Response to USEPA and NYSDEC Comments on PSD Air Permit Application and State Air Facility Permit Application (#3-1326-00275/00004)

This letter provides responses to agency review comments received on the PSD Air Permit Application and State Air Facility Permit Application for the proposed Cricket Valley Energy Center (CVE), which were submitted on March 26, 2010. Comments were provided by the United States Environmental Protection Agency (USEPA) Region 2 and the New York State Department of Environmental Conservation (NYSDEC) via the following correspondence:

**Cricket Valley Energy
Five-Year Average Maximum 1-Hour NO2 Impacts**

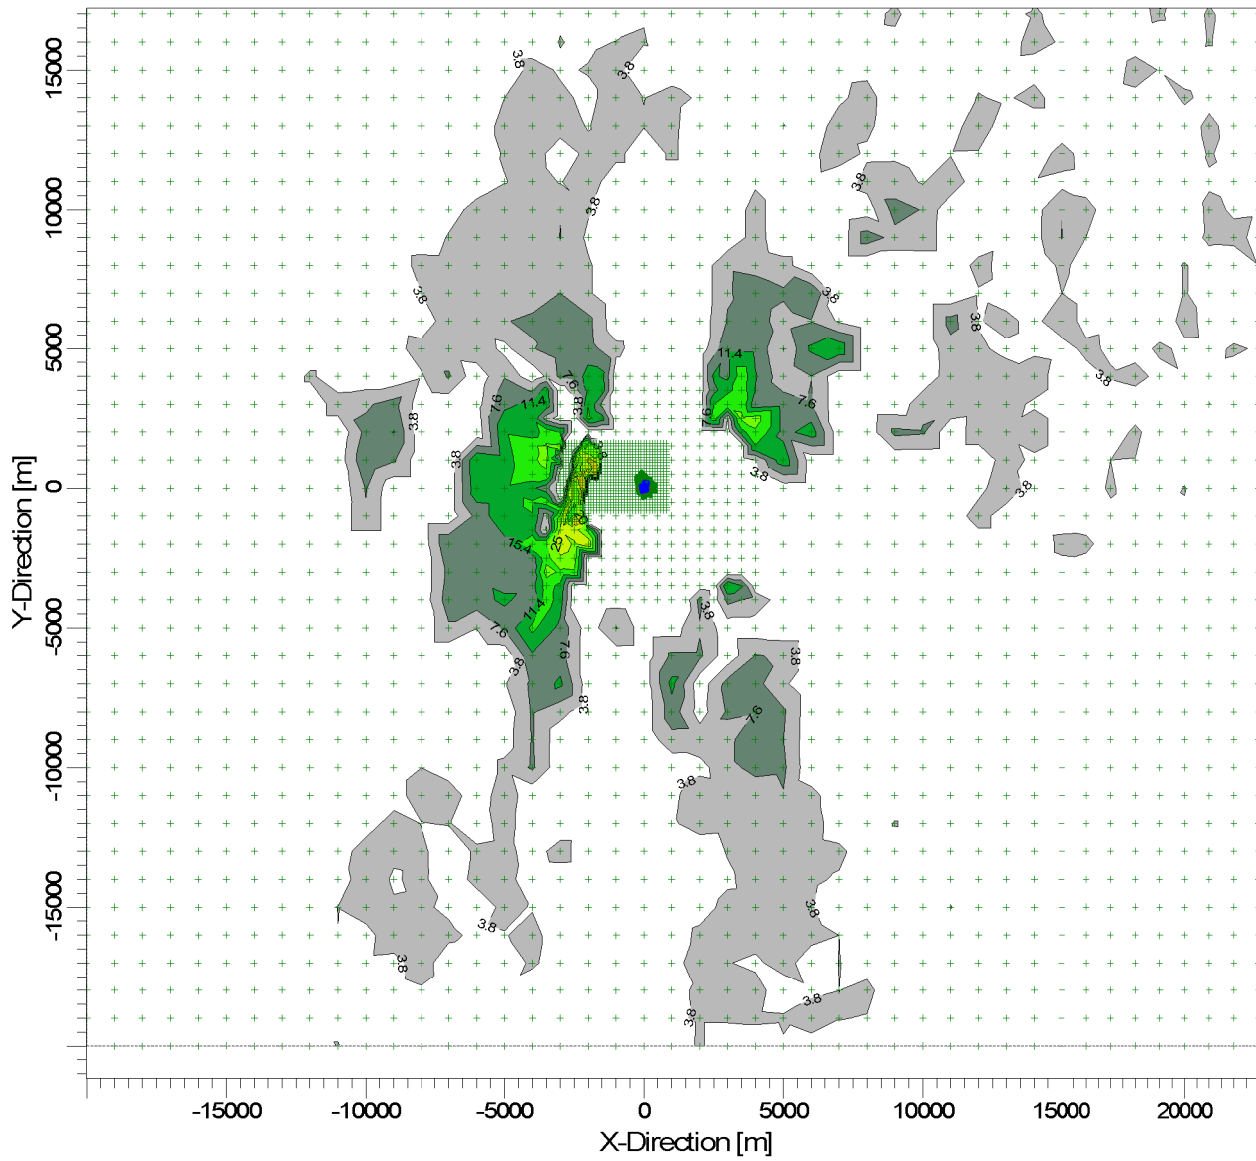
Comment USEPA-3: *A 1 hour NO₂ impact was presented. However, the modeling is not a cumulative assessment which includes other nearby sources. This assessment must be expanded to include a cumulative assessment with other nearby sources. You may want to note that USEPA will soon issue a clarification memo which will provide confirmation on the 3 tier processes in the Guideline on Air Quality Model as*

Response USEPA-3: A pair of USEPA memoranda, "Applicability of Appendix W Modeling Guidance for the 1-hour NO₂ NAAQS" and "Guidance Concerning the Implementation of the 1-hour NO₂ NAAQS for the Prevention of Significant Deterioration Program," were issued June 28, 2010. The "PSD" memo defines an interim SIL for 1-hour average NO₂. CVE project impacts have been assessed in relation to the interim SIL, following the modeling guidance provided in these memoranda. The results indicate that predicted CVE project impacts exceed the interim SIL, and a Significant Impact Area (SIA) of 29 km has been identified. The isopleth plot of 5-year average maximum predicted 1-hour impacts is provided as Attachment D. The emissions inventory for a cumulative assessment is currently being developed. ARCADIS is consulting closely with NYSDEC concerning this inventory development effort. Following completion of the cumulative modeling for the new 1-hour NO₂ NAAQS, CVE will submit a revised permit application incorporating these results as well as the information contained in this response letter.

Site Plan Depicting Stack Configuration

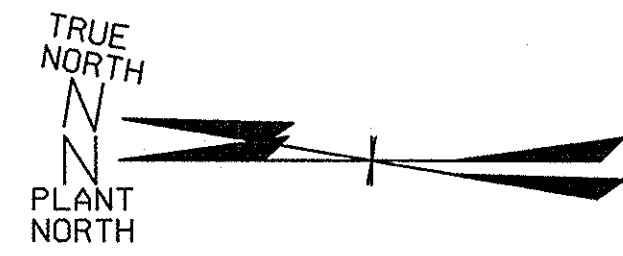
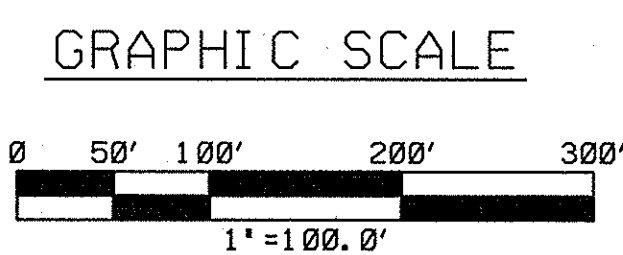
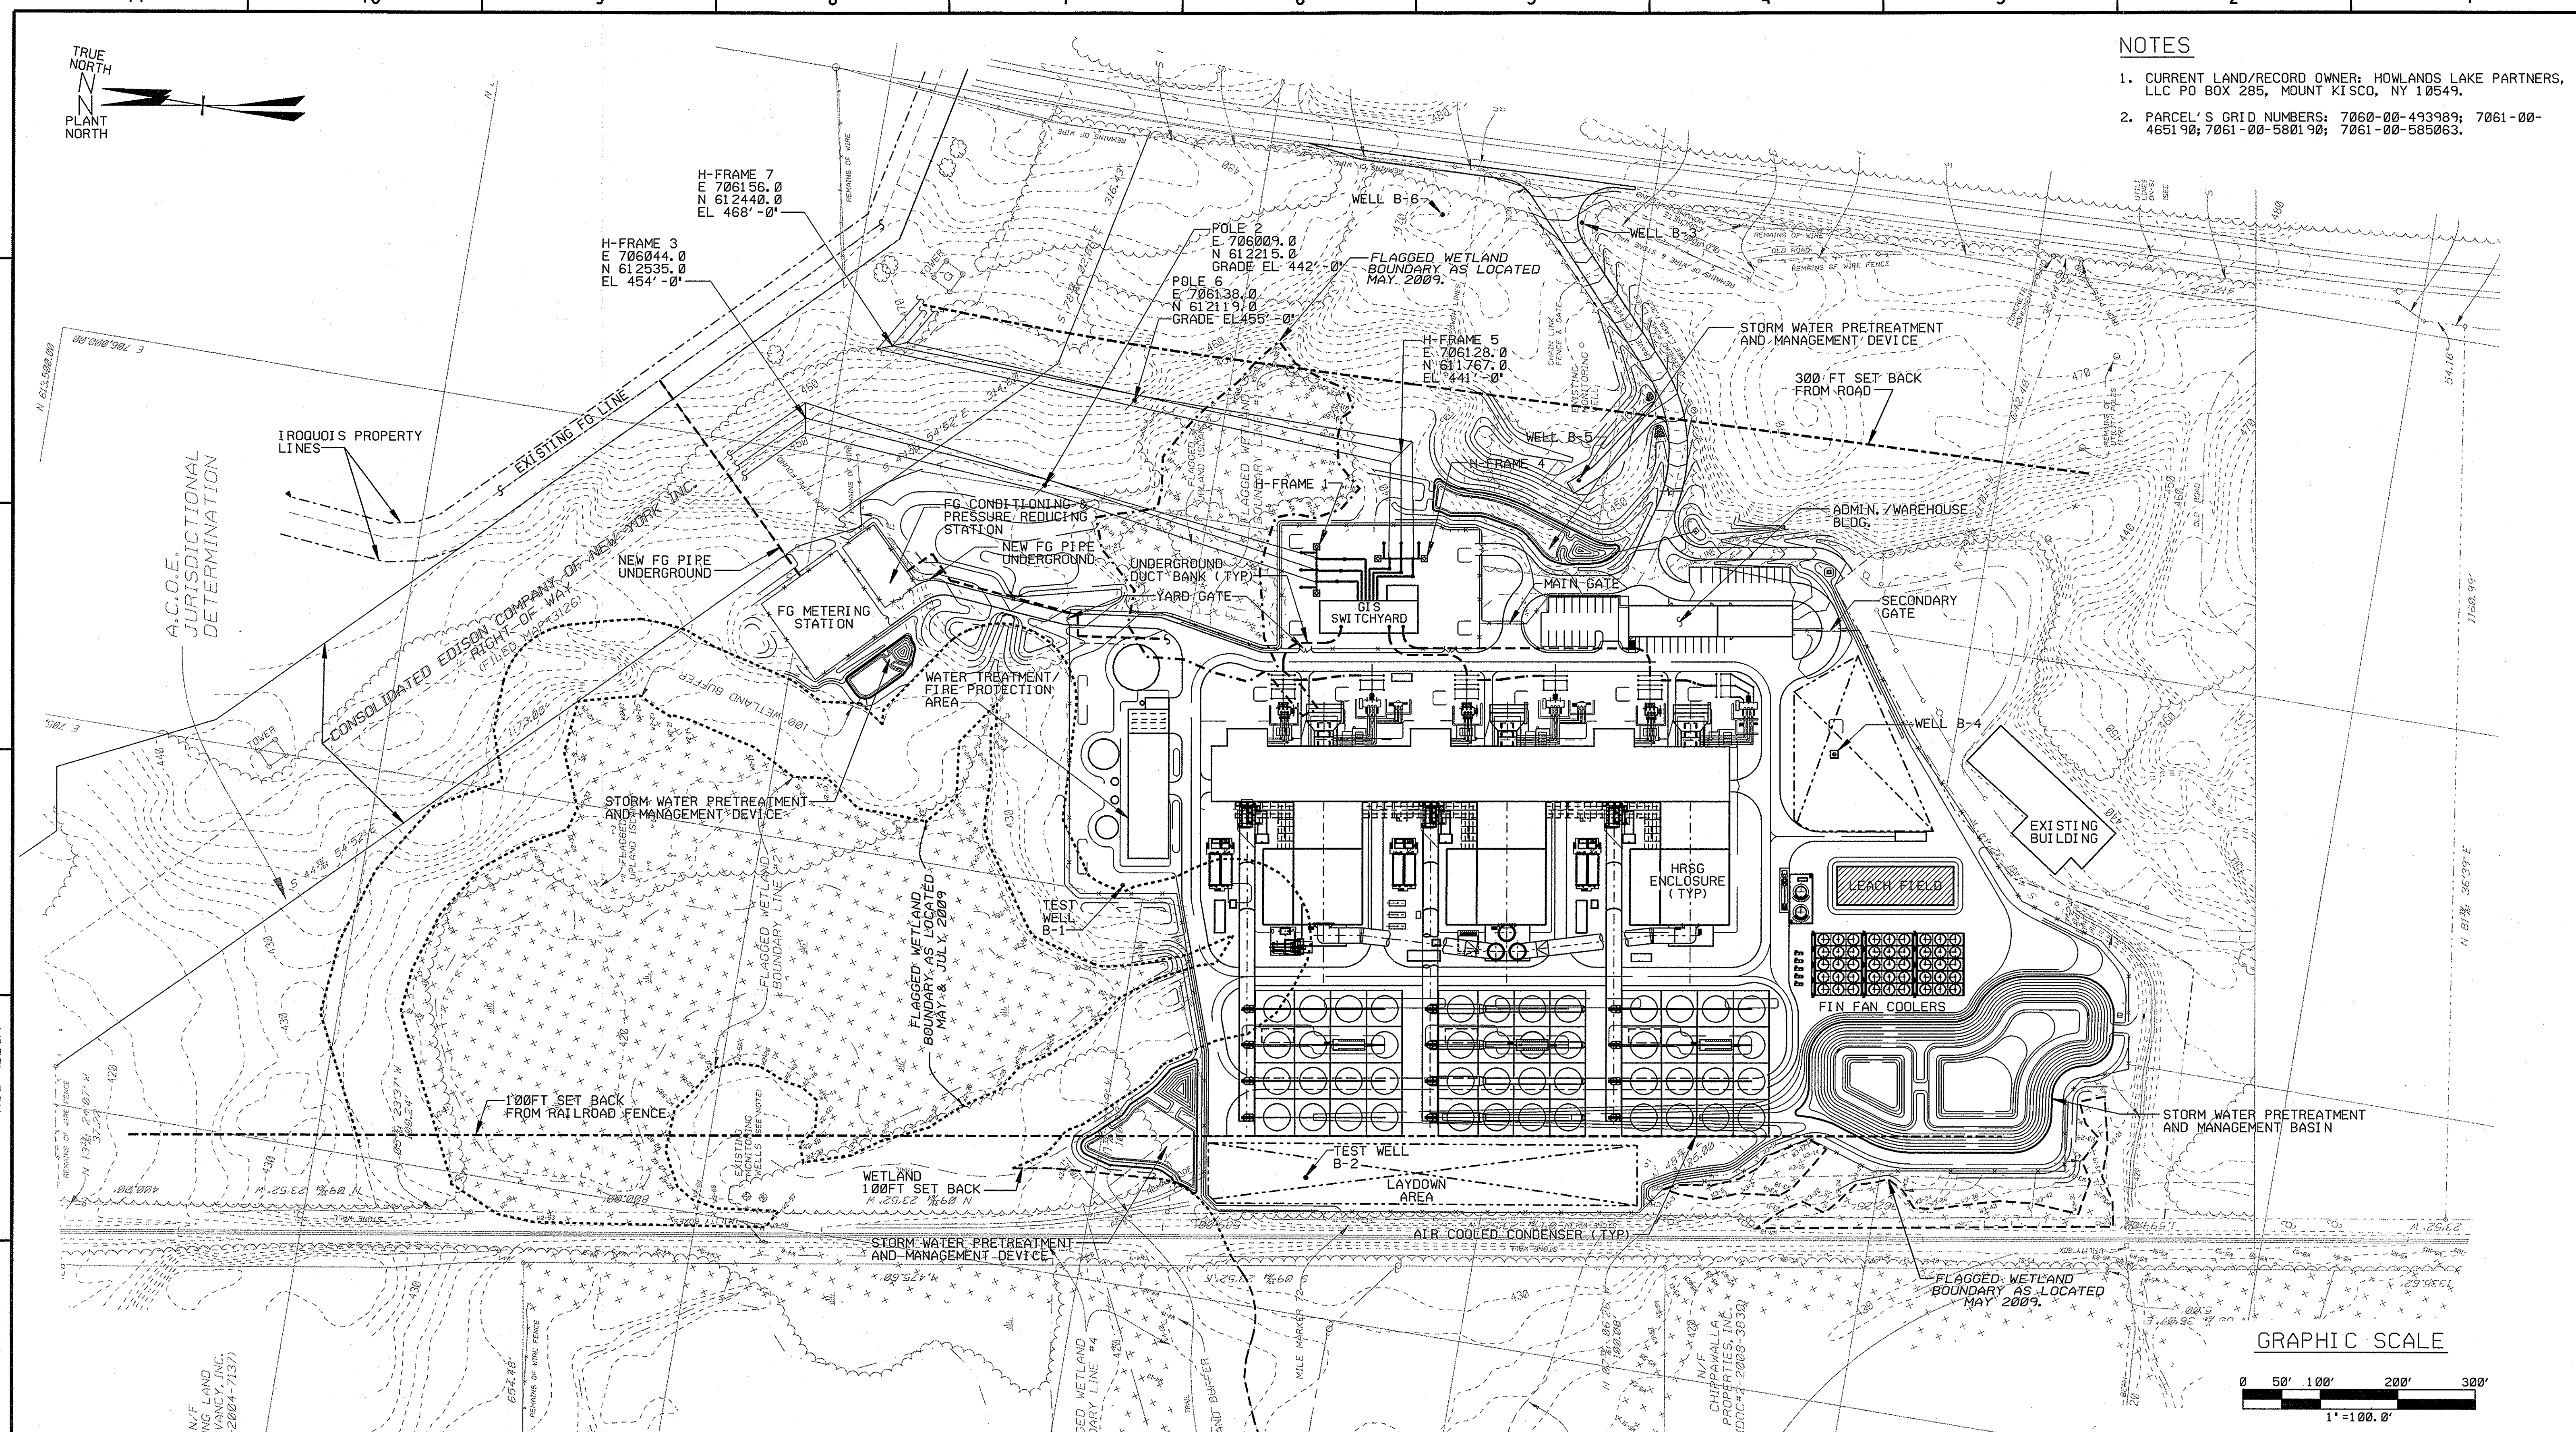
Comment USEPA-4: *The modeling assumed that the 3 turbine stacks were merged as one using a combined effective stack diameter. This may be acceptable provided that the separation distance is close enough where the plumes are truly merging. Generally, USEPA accepts this distance to be approximately 1 stack diameter. Please confirm that this is the case or provide further explanation for using the merged technique in the refined analysis.*

Response USEPA-4: The turbine stacks satisfy the USEPA criteria for modeling as a merged plume. The turbine stacks are 19 feet in diameter, and the separation distance between stacks is approximately 9 feet (less than 1 stack diameter). The site plan showing the configuration of the stacks is provided as Attachment E.

Attachment J

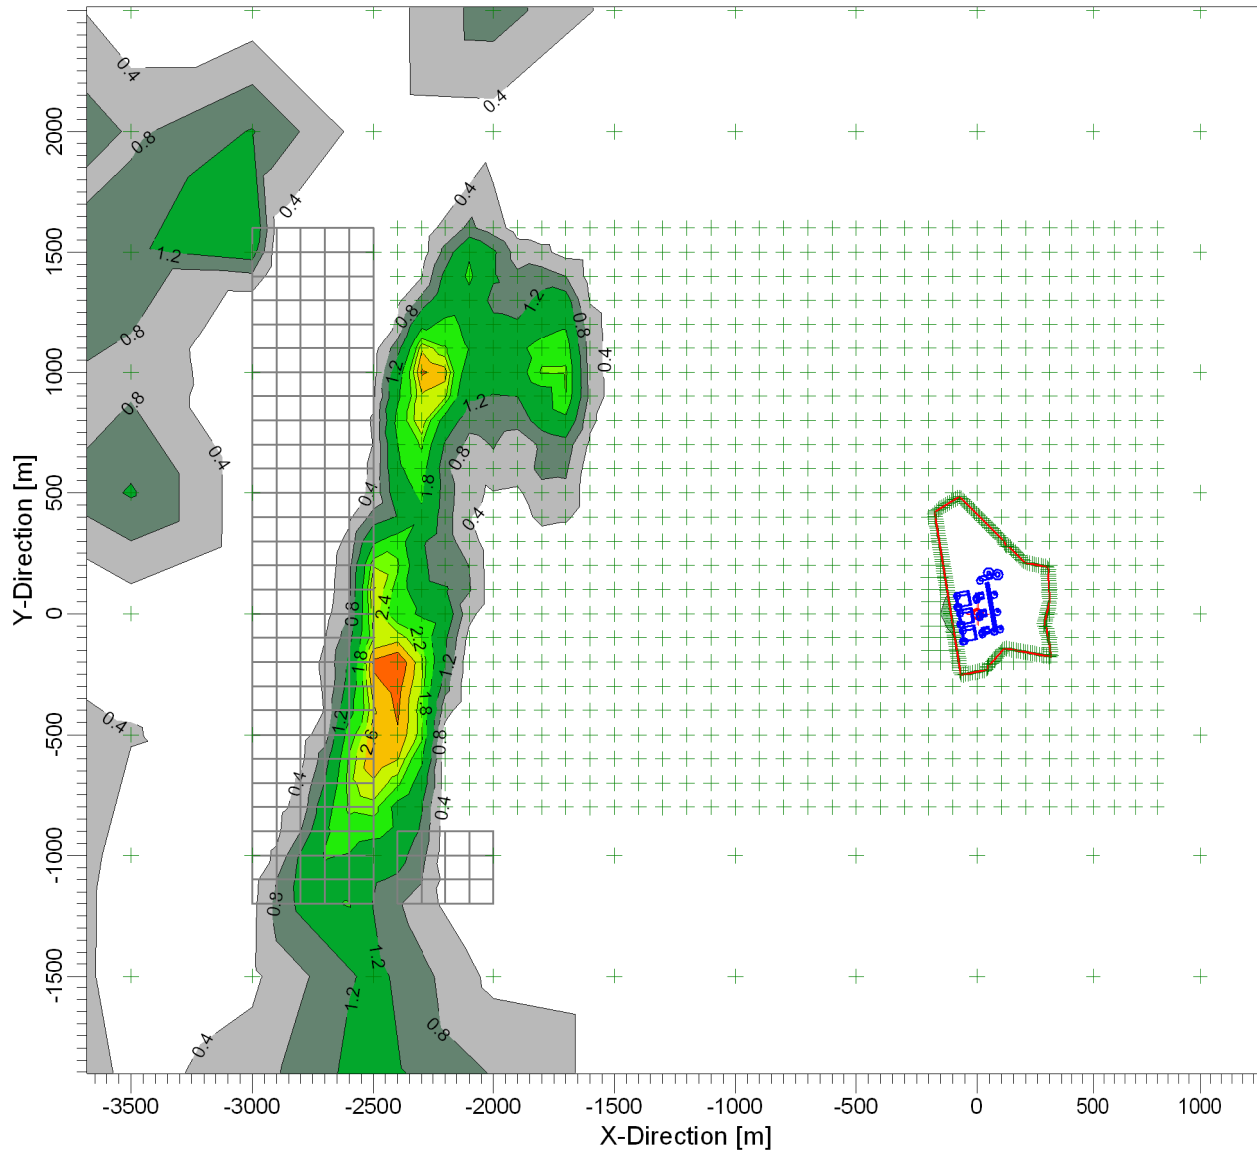
Comment NYSDEC-1: Maximum impacts are predicted at the edge of the 100m grid. The 100m grid should extend beyond these areas to ensure the maxima are modeled.

Response NYSDEC-1: Receptors were added to extend the area covered at 100 m resolution. The plot of 5-year average maximum predicted 24-hour impacts for PM-2.5 (Attachment J) demonstrates that the 100 m grid now extends beyond the area where maximum CVE project impacts are predicted.

HUNT COUNTRY
FURNITURE
(Elev: 344ft)

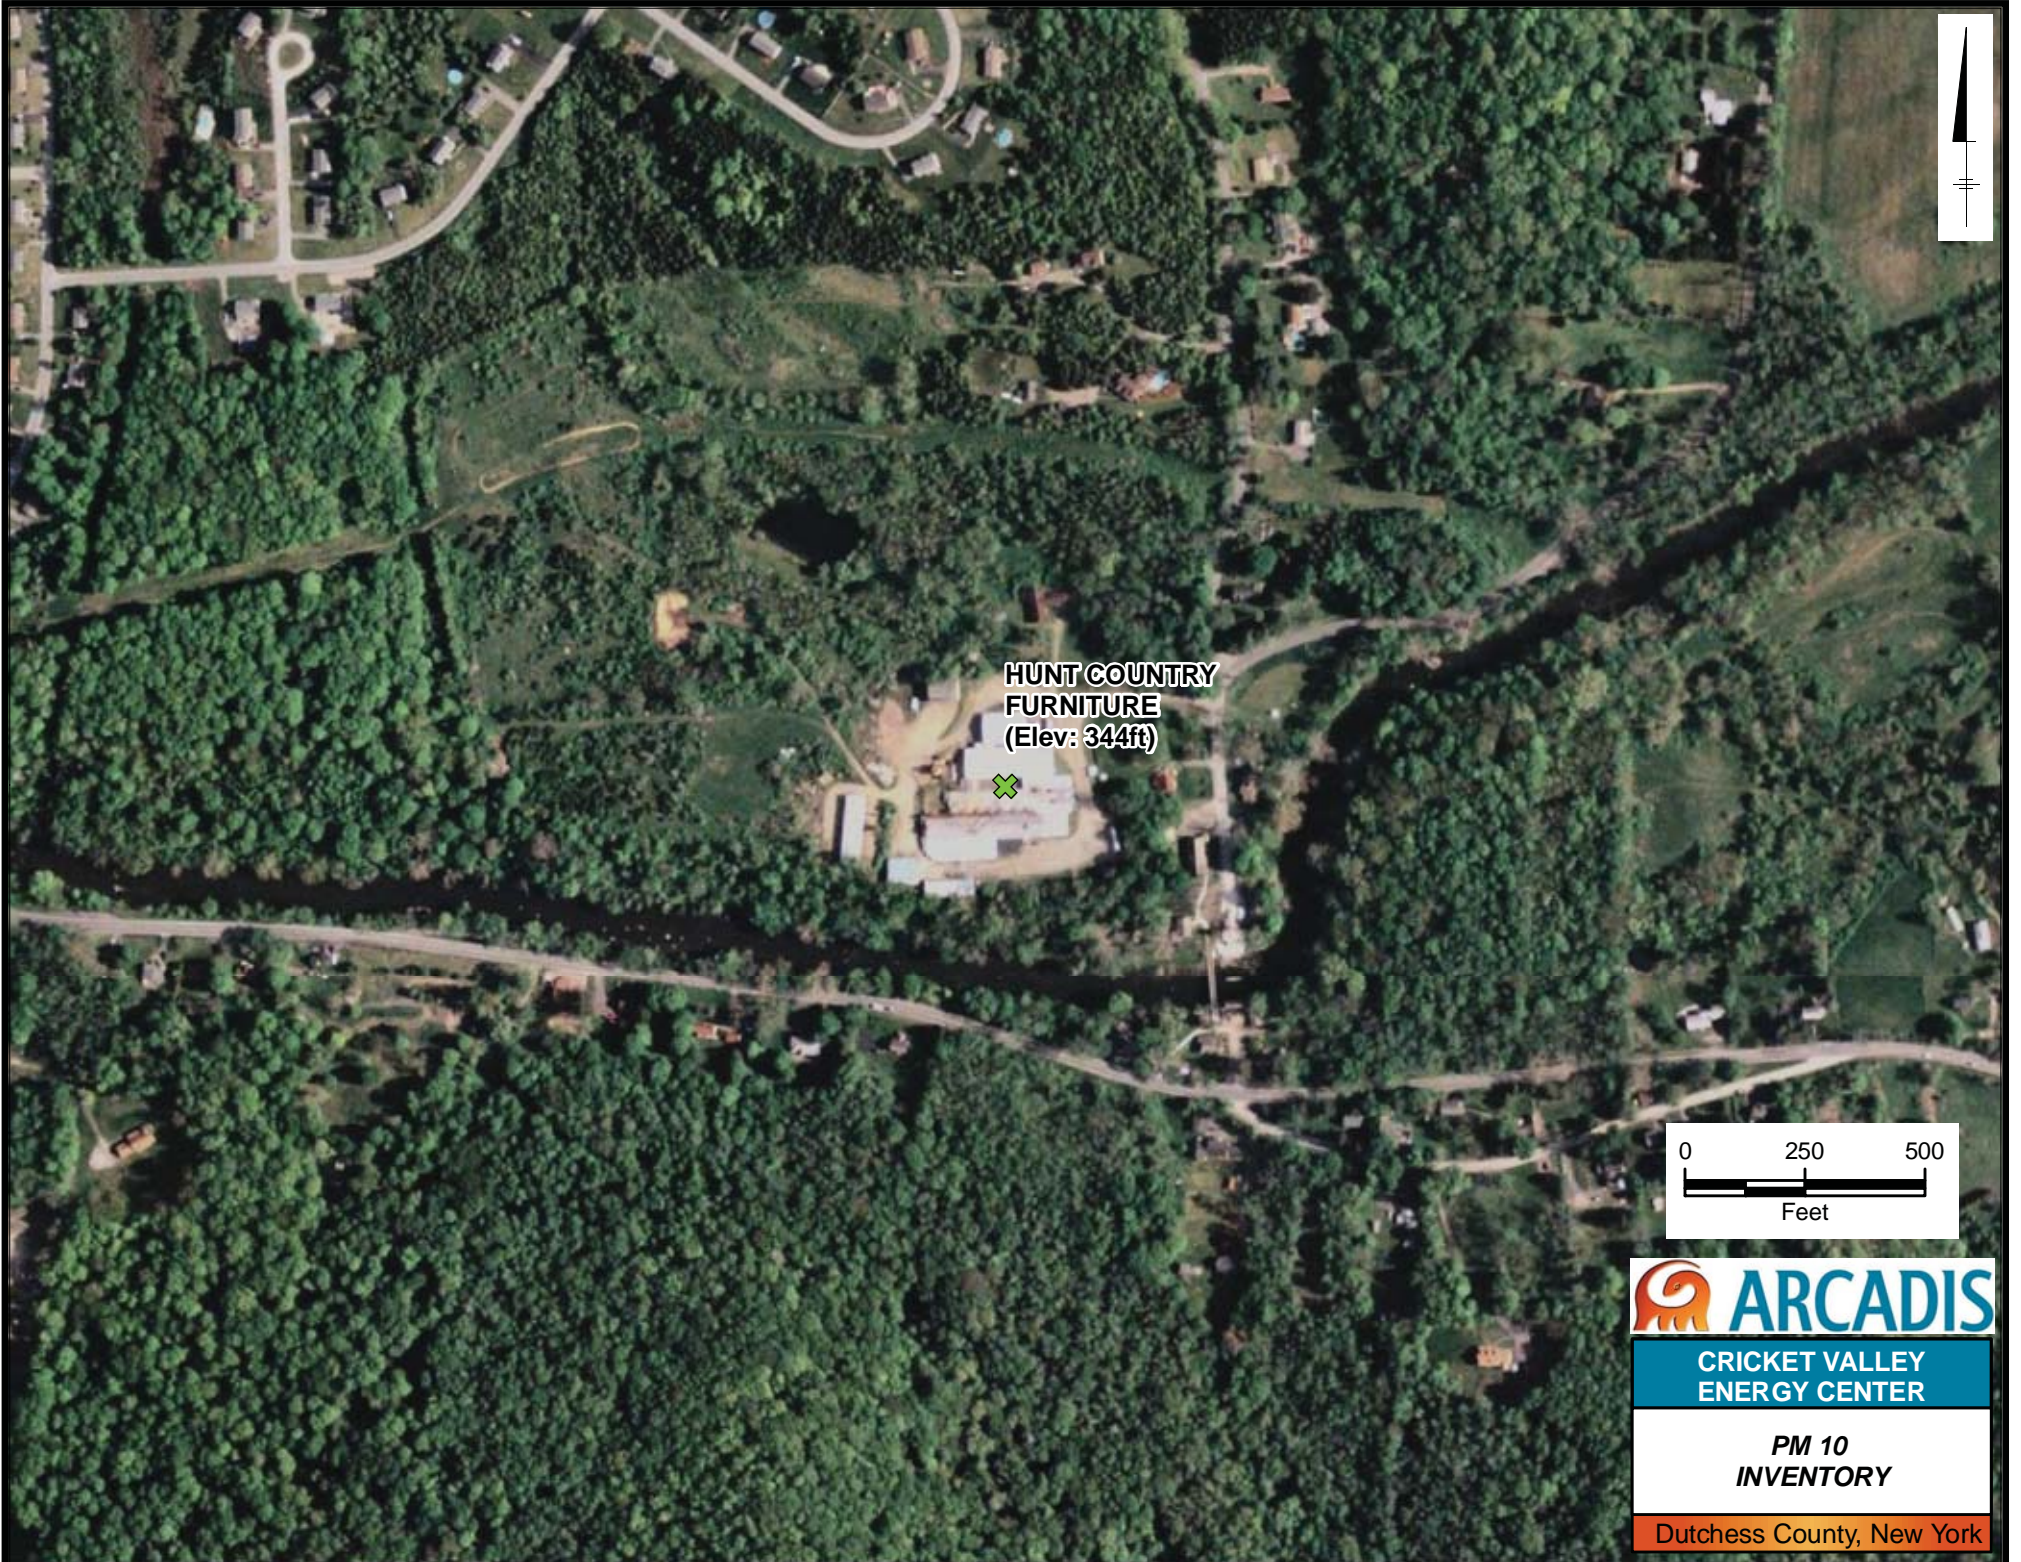
Comment NYSDEC-4: Coordinates for Hunt Country Furniture appear to be incorrect. Based on the address Webatuck Ln., Wingdale, I used Google Maps and ArcMap to estimate the coordinates to be: 621557E, 4612500N (UTM-18, nad83). These coordinates, and all other interactive source coordinates should be verified prior to performing any additional AERMOD runs.

Response NYSDEC-4: In response to this comment and subsequent discussions with NYSDEC, ARCADIS independently determined the location and elevation coordinates for each facility in the cumulative impact inventory for PM_{2.5}. Revised coordinates were reviewed with NYSDEC and then incorporated into the revised PM_{2.5} emissions inventory. Documentation relating to source locations is provided as Attachment K.
